# Access Compliance Report

## Public Rights-of-Way (Curb Ramps)

Intersection ID: 44170	Main Street: PAWPAW_LN	Cross Street: PRAIRIE_VALLEY_DR	Location: E
ADA ID: 5DF3C1E31072	Ramp Type: PerpDiag	Initial Pass/Fail: Fail	Overall Compliance: No
Severity Score: 8.75			
Codes/Mitigation Info/Possible Solution		Field Measurements/Component Compliance

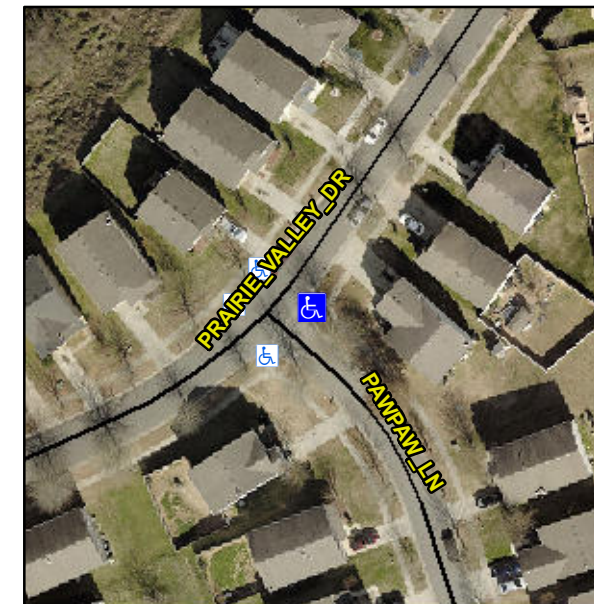
**Not Found, R304.5.1**

Compliance	Description	Data	Compliance	Description	Data
N/A	Ramp Length (in)	86.0	Yes	Ramp Slope (%)	6.7
No	Ramp Width (in)	45.5	Yes	Ramp XSlope (%)	1.4
N/A	Flare Type LT	N/A	N/A	Flare Type RT	N/A
N/A	Flare Slope LT (%)	N/A	N/A	Flare Slope RT (%)	N/A
N/A	Flare Traversable LT?	N/A	N/A	Flare Traversable RT?	N/A
N/A	Landing Length (in)	N/A	N/A	DWS Provided?	N/A
N/A	Landing Width (in)	N/A	N/A	DWS Contrast?	N/A
N/A	Landing Slope (%)	N/A	N/A	DWS Length (in)	N/A
N/A	Landing X Slope (%)	N/A	N/A	DWS Full Width?	N/A
N/A	Landing Curb? (Y/N)	N/A	N/A	DWS Offset (in)	N/A
N/A	Shared Landing?	N/A			
N/A	Gutter Ponding?	N/A	N/A	Gutter Slope (%)	N/A
N/A	Gutter Lip Ht (in)	0.5	N/A	Gutter X Slope (%)	N/A
N/A	Painted X Walk1?	No	N/A	Painted X Walk2?	No
	X Walk 1 Direction	To NW		X Walk 2 Direction	To SW
N/A	X Walk 1 Width (in)	N/A	N/A	X Walk 2 Width (in)	N/A
	X Walk 1 Slope (%)	1.0		X Walk 2 Slope (%)	0.5
	X Walk 1 X Slope (%)	1.3		X Walk 2 X Slope (%)	0.8

**Remove & Replace Curb Ramp With Two New Directional Ramps or Equivalent.**
